API Number 30-025-42-52-3			Pool Code 98110 WC-025 G-09 5253509D; 1			3509D.B	NE GA		
714771		Property Name SKULL CAP STATE COM					Well Number 2H		
OGRID No. 229137			COG OPERATING, LLC				glevation 3286.0		
					Surface Loc	ation			
UL or lot No.	Section	Township	Range	Lot Idn	Feet from the	North/South line	Feet from the	East/West line	County
J	32	24-S	35-E		2590	SOUTH	1980	EAST	LEA
			Bottom	Hole Loc	ation If Diffe	erent From Sur	face		
UL or lot No.	Section	Township	Range	Lot Idn	Feet from the	North/South line	Fest from the	East/West line	County
J	5	25-S	35-E		1650	SOUTH	1980	EAŞT	LEA .
Dedicated Acres	Joint o	r Infill Co	nsolidation	Code Ore	ier No.	**************************************		1	
200.72	1			1					
NO ALLO	WABLE V					ONTIL ALL INTER APPROVED BY		EEN CONSOLIDA	TED
				[OPERAT	OR CERTIFICA	TION

CONDITIONS OF APPROVAL

API#	Operator	Well name & Number
30-025-42523	COG OPERATING LLC	SKULL CAP STATE COM # 002H
Applicable cond	itions of approval marked with)	XXXXXX

Form C-102 Revised August 1, 2011 Submit one copy to appropriate District Office

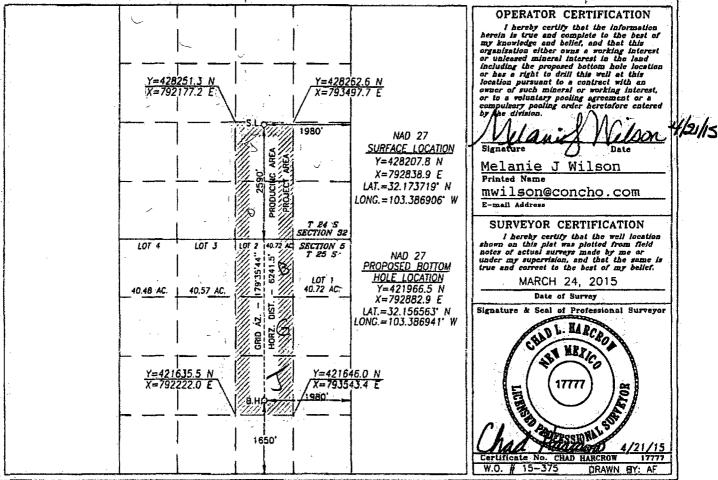
Administra	tive Orders Required	
XXXXXX	Will require administrative order for non-standard location prior to placing the well on production	
XXXXXXX	Will require administrative order for non-standard spacing unit	
Other wells		
Drilling		
XXXXXXX	Once the well is spud, to prevent ground water contamination through whole or partial conduits from the surface, the operator shall drill without interruption through the fresh water zone or zones and shall immediately set in cement the water protection string	
Casing	<u></u>	
XXXXXXX	SURFACE & INTERNEMIATE(1) CASING - Cement must circulate to surface	
XXXXXX	PRODUCTION CASING - Cement must tie back into intermediate casing	
XXXXXX	LINER - Cement must tie back into production casing	
XXXXXX	If cement does not circulate to surface, must run temperature survey or other log to determine top of cement

XXXXXX	If using a pit for drilling and completions, must have an approved pit form prior to spudding the well
	·
	·

Surface casing must be set 25' below top of Rustler Anhydrite in order to seal off protectable water

XXXXXXX	Will require a directional survey with the C-104
